Request for Continued Examination (RCE) Transmittal

Application Number	10/798,693
Filing Date	03/11/2004
First Named Inventor	Stanton
Art Unit	3673
Examiner Name	LEE
Attorney Docket Number	CLPS-18789

RESPONSE TO OFFICE ACTION DATED JUNE 10, 2009

Amendments to the Drawings: Replacement Sheets for Figures 4, 6, and 12.

FIG. 6

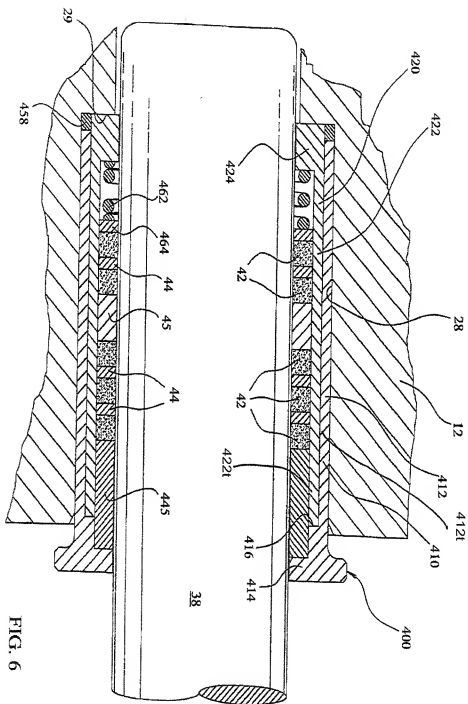
The drawings were objected to under 37 CFR 1.83(a) because the specific terms “telescoping structures” as used in the currently- pending claims were not identified in the drawings. Applicants amend as required by the Examiner.

Regarding Figures 6 and 12, Paragraphs 0156 and 0158 of the specification are amended to include the specific references 412t and 422t for the “telescoping structures” and Figures 6 and 12 of the drawing is amended to include these references. Figure 12 is a cross-sectional view of another embodiment of a packing cartridge similar to the embodiment shown in Figure 7 (*See, e.g.*, Specification Paragraphs 0076 and 0193), where Figure 7 is a cross-sectional view of another embodiment of a packing cartridge similar to the embodiment shown in Figure 6 (*See, e.g.*, Specification Paragraphs 0068 and

[0156] Preferably, a spacer ring **445** is positioned operatively to cover the overlapping travel of the telescoping structures 422t and 412t between the first and second sleeve portions **410** and **420**. This spacer ring **445** helps prevent seepage of fluid into any clearances between the first sleeve portion **410** and the second sleeve portion **420**. The spacer ring **445** can also act as a back-up ring for the packing rings **42**.

[0158] As will be appreciated, the telescoping structures 422t and 412t of the first sleeve portion **412** and the second sleeve portion **422** allow for squeezing of the first abutment ring **414** and the second abutment ring **424** co-axially closer to one another after positioning the pre-assembled packing cartridge **400** on a plunger **38** in the packing bore **28**. However, in this embodiment, the packing cartridge **400** is positioned in the packing bore **28** and tightened by a gland nut (not shown) until the second sleeve portion **422** bottoms out against a shoulder **416** of the first sleeve portion **412**. In this position, the coil spring **462** is compressed with a packing assembly positioned between the first abutment ring **414** and a second abutment ring **424**. The advantage of bottoming out the telescoping structures 422t and 412t is that it prevents over-tightening of the packing cartridge **400** in the packing bore **28**. The spring **462** maintains a pre-determined amount of axial compression on the packing rings **42** of the packing stack.

FIG. 12

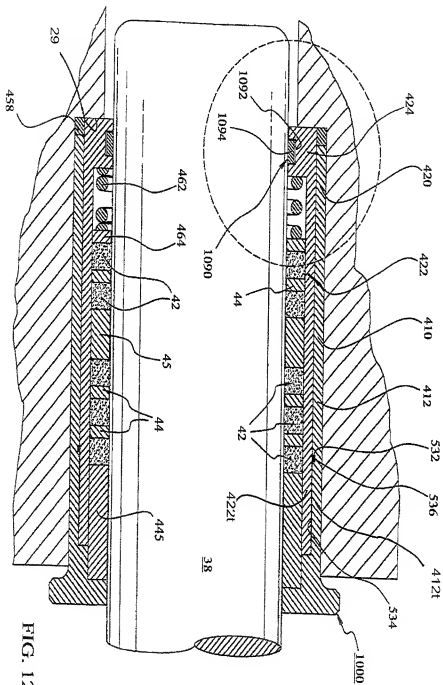
In response to the new objection to the drawing in the Final Office Action of June 10, 2009, Applicants respectfully note that a “seat 29” is indicated in Figures 1, 3, 3a, 6, 9, 14a, 15, and 17. Figure 7 is similar to Figure 6 as described in Paragraph 0161, and Figure 12 is similar to Figure 7 as described in Paragraph 0193. In addition, the Replacement Sheet for Figure 12 submitted herewith is amended to indicate seat 29.
